Informal document GRE-85-19  
85th GRE, 26-29 October 2021,  
agenda item 4 (e)

**Proposal for amendments to ECE/TRANS/WP.29/GRE/2020/8/Rev.2**

## **Revised proposal for a new [0x] series of amendments to UN Regulation No. 48**

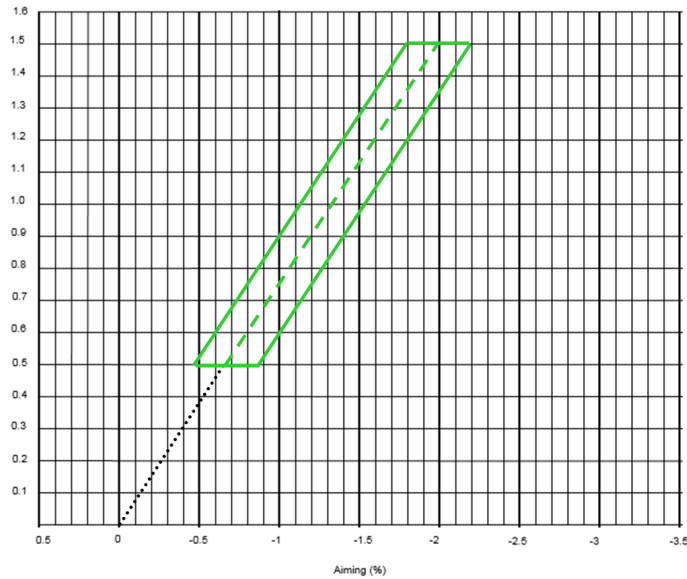
**The initial downward inclination of the cut-off of the passing-beam (dipped-beam) shall be:**

- set in the unladen vehicle state with one person in the driver's seat,
- specified within an accuracy of 0.1 per cent according equation:

**$I = -h/0.75$  (dashed line on drawing below)**

**where:**

**I – cut-off inclination (in %);**

**h - mounting height of headlight optical axis (in m)**

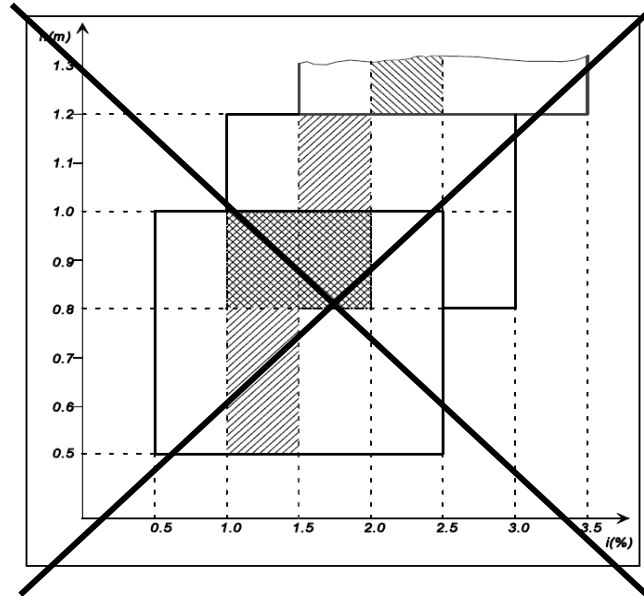
**6.2.6.1.2.2. However while it is impossible to meet requirements specified in paragraph 6.2.6.1.2.1. because of design constraints of vehicle which are impossible to avoid it is satisfactory to meet below prescribed limits.**

<i>Mounting height h [m]</i>	<i>Upper inclination limit [per cent]</i>	<i>Lower inclination limit [per cent]</i>
$0.5 \leq h \leq 0.9$	-0.20	-1.40 to -1.80*
$0.9 < h \leq 1.2$	-0.20 to -0.85*	-1.80 to -2.45*
$1.2 < h \leq 1.5^{**}$	-0.85 to -1.50*	-2.45 to -3.10*

The above limits and the initial aiming values are summarized in the diagram below.

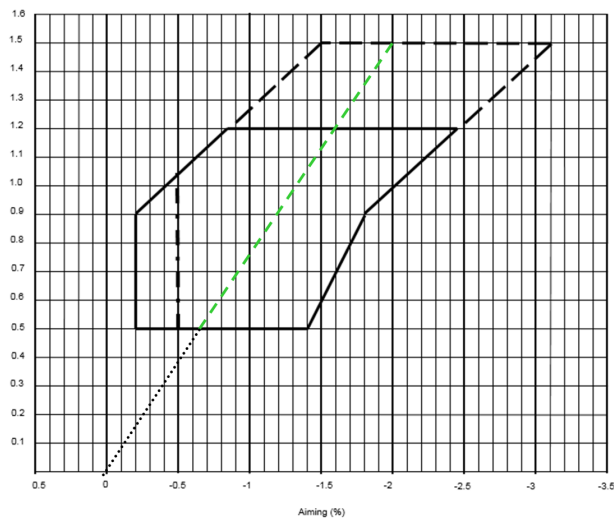
~~For category N<sub>3</sub>G (off road) vehicles, where the headlamps exceed a height of 1,200 mm the limits for the vertical inclination of the cut-off shall be between: 1.5 per cent and 3.5 per cent~~

~~The initial aim shall be set between: 2 per cent and 2.5 per cent.~~

**“The controls for the headlamp-levelling devices referred to in paragraph 6.2.6.2.2. of this UN Regulation**

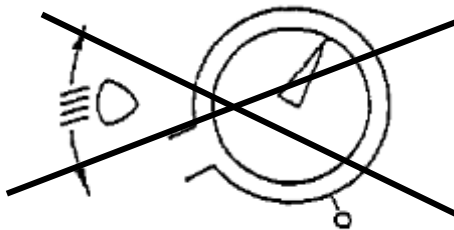
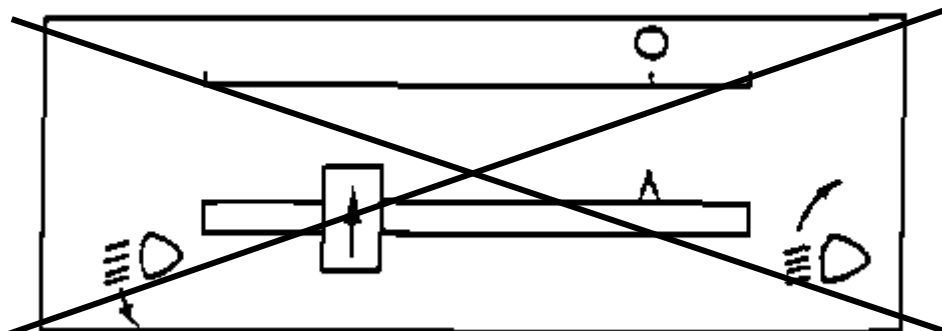
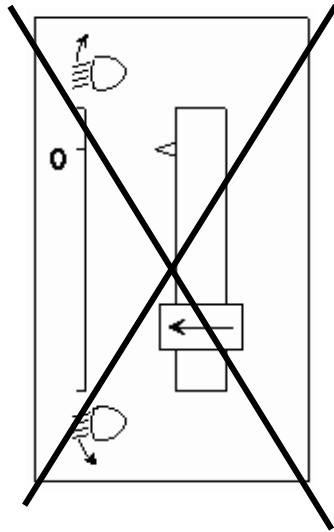
1. Specifications
- 1.1. ~~Downward~~ Inclusion of the dipped-beam shall in all cases be produced by a **simple control, the operation of which is clearly described in the owner’s handbook. in one of the following ways:**
  - (a) ~~by moving a control downwards or to the left;~~
  - (b) ~~by rotating a control in a counter clockwise direction;~~
  - (c) ~~by depressing a button (push pull control).~~

If several buttons are used to adjust the beam, the button which gives the greatest downward inclination shall be installed to the left or below the button(s) for other dipped beam positions.

A rotary control that is installed edge on, or with only the edge visible, should follow the operating principles of control of types (a) or (c).
- 1.1.1. This control shall carry symbol(s) indicating clearly the movements corresponding to the downward and upward inclination of the dipped-beam.
- 1.2. The "0" position corresponds to the initial inclination according to paragraph 6.2.6.1.1. of this Regulation.
- 1.3. ~~The marks used on control shall be explained in the owner's handbook.~~
- 1.4. ~~Only the following symbols may be used to identify the controls:~~
